## Product Change Notification / GBNG-19TOBI439

CCB 4885 Initial Notice: Qualification of CEL-8240 GS as a new mold compound material for selected Supertex CL2xx, CL52xx, LND150, MCP15xx, MCP170x and MCP970xx device families available in 3L TO-92 package assembled at CRTK assembly site.

**CCB 4885**  
**Pre and Post Change Summary**  
**PCN #: GBNG-19TOBI439**

# Lead Frame Comparison

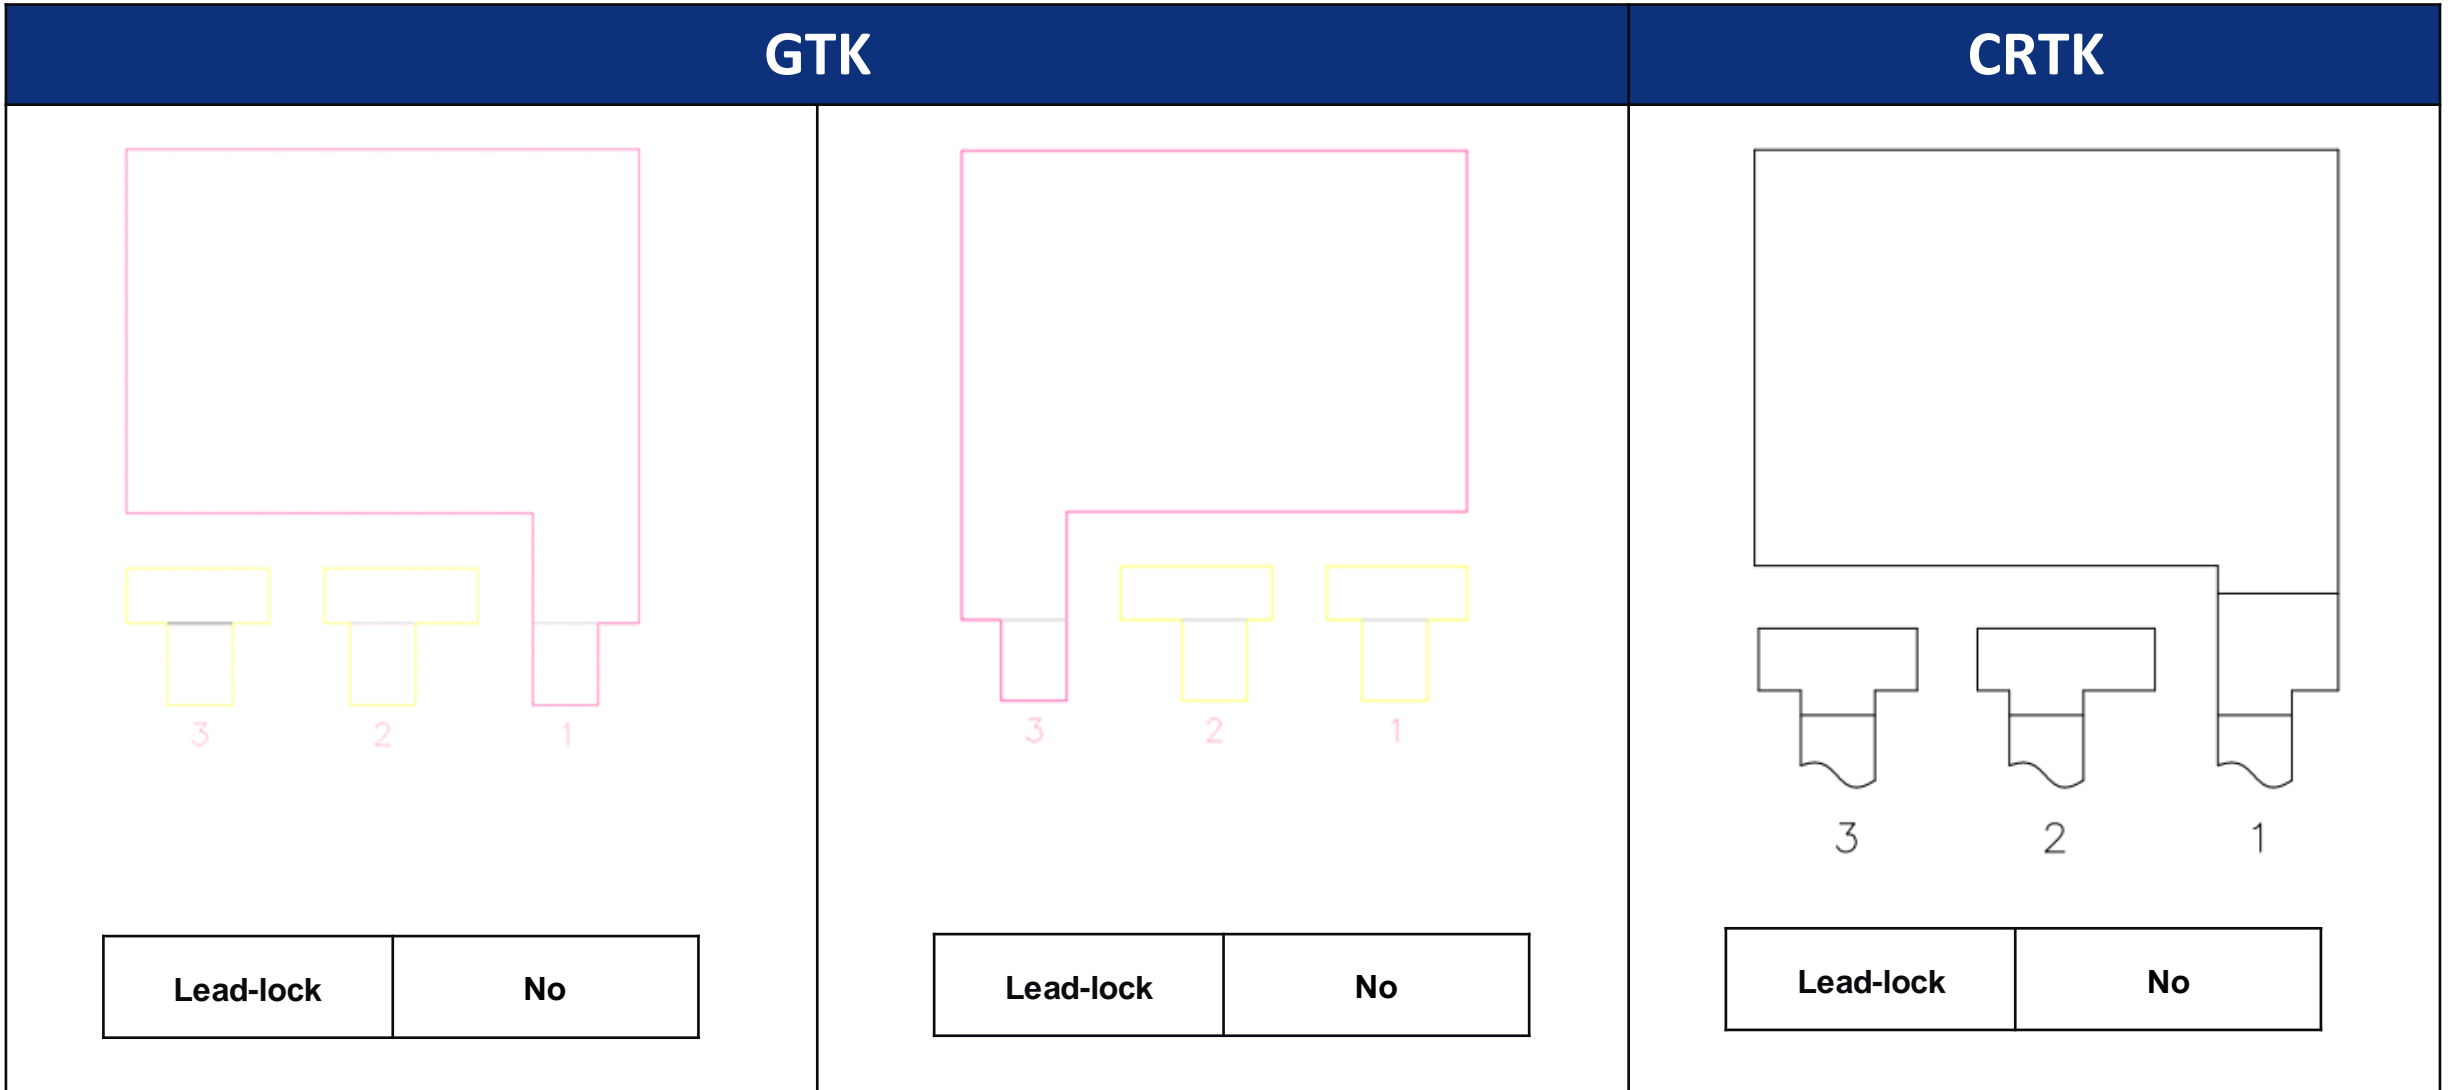
Note: Mold compound material fills the leadlock hole, which provides improved protection against moisture penetration along the edge of the leads (pins) of the package.

# Package Lay-out

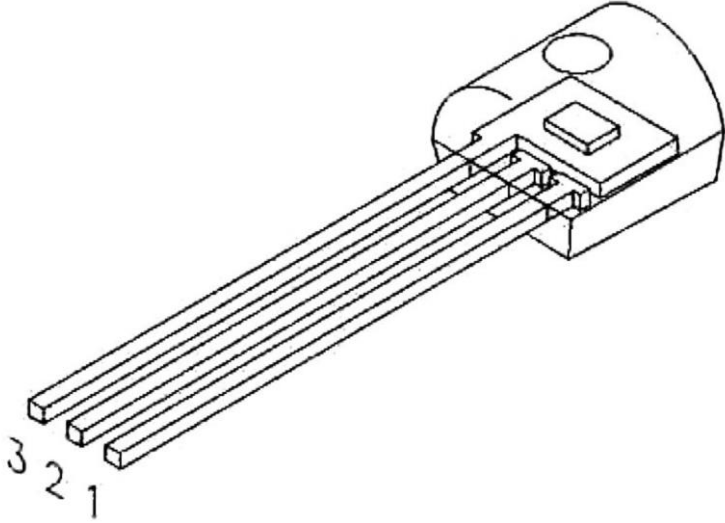
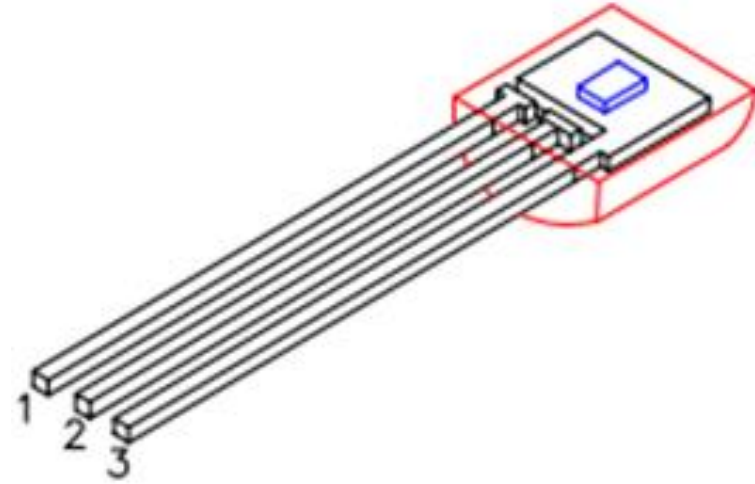
Die sit on flat side
